UNITED STATES PATENT AND TRADEMARK OFFICE

APPLICATION NO.	FILING DATE	FIRST NAMED INVENTOR	ATTORNEY DOCKET NO.	CONFIRMATION NO.
09/385,020	08/30/1999	SHUNPEI YAMAZAKI	0756-2023	8609

Office Action Summary	Application No. 09/385,020	Applicant(s) YAMAZAKI, SHUNPEI	
	Examiner Kevin M. Nguyen	Art Unit 2629

DETAILED ACTION

FIG. 16

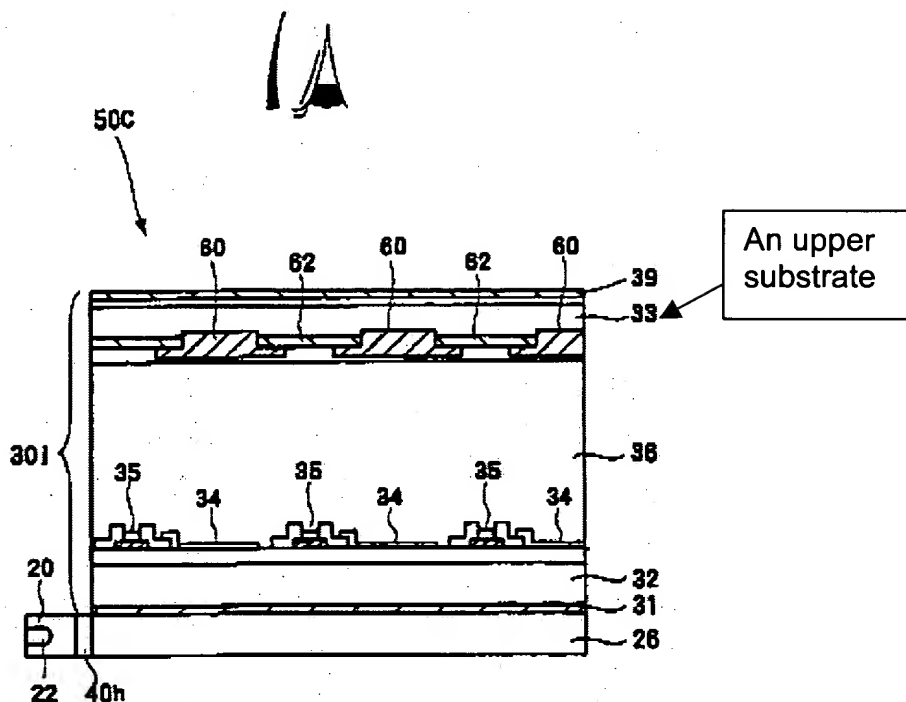
A reflection type liquid crystal panel [36] comprising an active matrix substrate [32] and a counter substrate [33], and a color filter adjacent to the counter substrate

[color filters 60 is adjacent to the upper substrate 33ⁱ, see Fig. 16], wherein said active matrix substrate having a plurality of thin film transistors [35] and a plurality of pixel electrodes [34] connected with the thin film transistors [see fig. 18, see col. 20, lines 26-42),];

a reflection plate [20] located adjacent to the liquid crystal panel [36a, Fig. 18] with the light emitting diodes interposed therebetween, said light emitting diodes and the reflection plate arranged horizontally with respect to the liquid crystal panel [see Fig. 16 and 18, col. 20, lines 27-45];

wherein white light emitted from the light source [22] is introduced into said active matrix substrate [32, see Fig. 16, col. 19, lines 25-61] from sides of said liquid crystal panel is reflected on the pixel electrode so as not to pass through the active matrix substrate [see Fig. 18, col. 20, lines 27-45].

5. As to claim 8, Komoto teaches the upper substrate 33ⁱ (the counter substrate, see fig. 16).

8. As to claims 13, 17, 21, 25, Komoto teaches the transparent substrate 32 (fig. 16) is alkali glass (see fig. 16, col. 13, lines 38-49), and the upper substrate 33ⁱ (a counter substrate, see fig. 16) is a glass.

FIG. 12

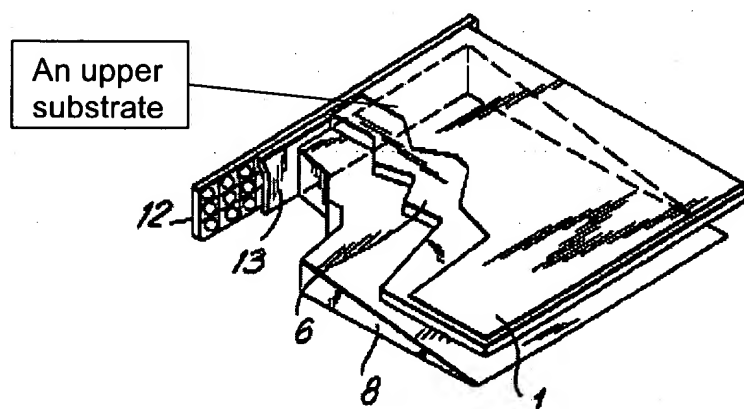
However, Sonehara teaches a related LCD device which includes the light source [12] for emitting and propagating the white ray into a plurality of substrates in a liquid crystal panel [6] from sides, wherein at least a part of the white ray of the light source [12] introduced to the plurality of substrates, which includes the upper substrate [see Fig. 12, col. 7, line 66 through col. 8, line 24].

It would have been obvious to a person of ordinary skill in the art at the time of the invention was made to replace the light source [12] in the active matrix liquid crystal panel of Komoto with the light source [22] for emitting and propagating the additional white ray into the upper substrate (corresponding to the counter substrate) in the active matrix liquid crystal panel of Komoto, as taught by Sonehara in order to achieve the benefit of improving color display device having a bright and high purity of color in saturation and superior color reproduction by combining color filters (see Sonehara, col. 1, line 57 through col. 2, line 2).
